Appl. No. 09/661,136 Amdt. dated 03/09/2005 Reply to Office action of 12/09/2004

## Amendments to the Drawings:

The attached sheets of drawings include changes to Figs. 2, 5 and 6. These sheets, which include Figs. 2, 5 and 6, replace the replacement sheets including Figs. 2, 5 and 6, filed on December 28, 2004.

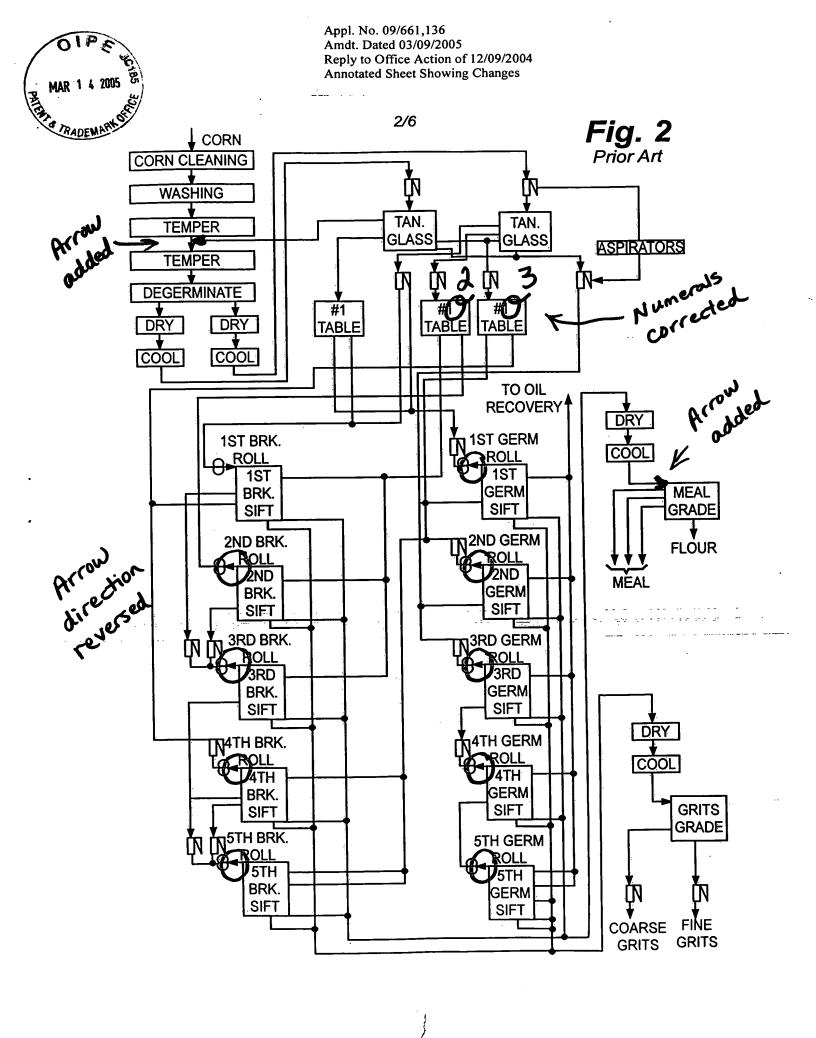
In Figure 2, two of the three gravity tables labeled #1 TABLE (both occurrences) have been corrected to properly indicate #2 TABLE and #3 TABLE, respectively. An arrowhead has been added to indicate flow from TAN. GLASS to TEMPER, and another arrowhead has been added to indicate flow from COOL into MEAL GRADE. The arrows indicating material flow to the 2<sup>nd</sup> through 5<sup>th</sup> break sifters (2<sup>ND</sup> BRK. SIFT et al) and the 1<sup>st</sup> through 5<sup>th</sup> germ sifters (1<sup>st</sup> GERM SIFT et al) have been corrected to properly indicate flow into those units.

Appl. No. 09/661,136 Amdt. Dated 03/09/2005 Reply to Office Action of 12/09/2004 Annotated Sheet Showing Changes

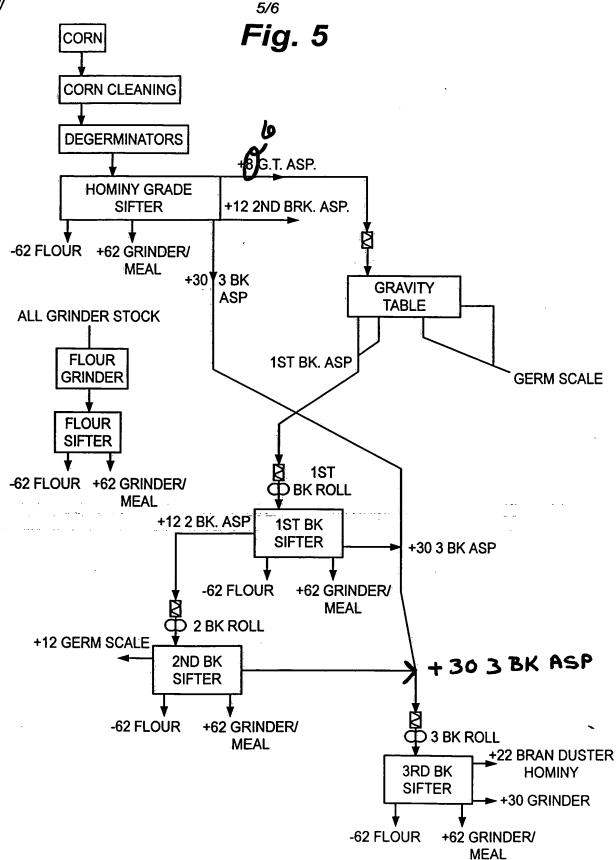
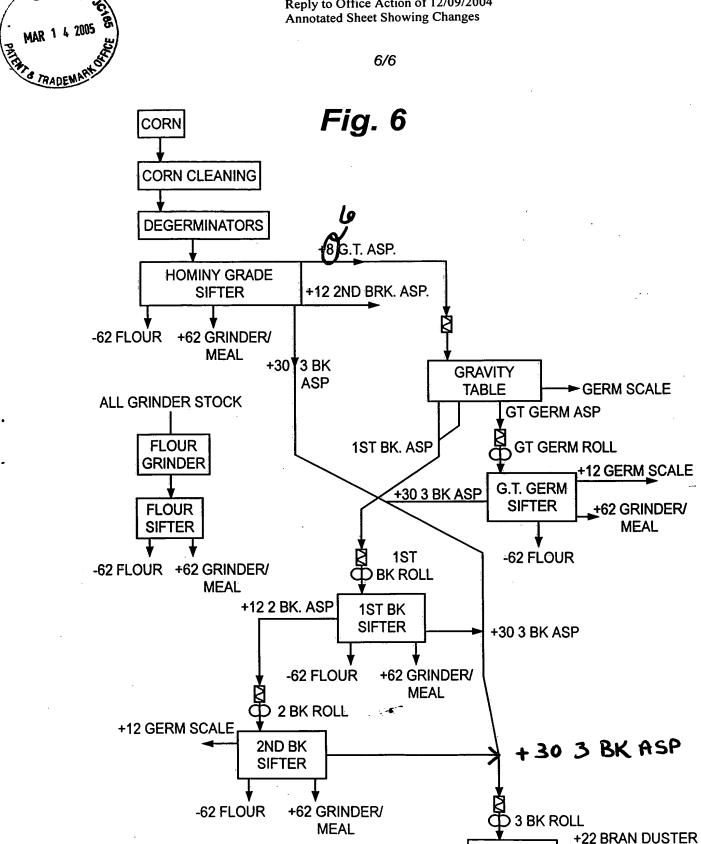
In both Fig. 5 and Fig. 6, the legend "+8 G.T. ASP." has been corrected to properly indicate +6 G.T. ASP., and the legend "+30 3 BK ASP" and an arrow have been added to indicate material flow from the 2<sup>nd</sup> BK SIFTER to the 3 BK ROLL.
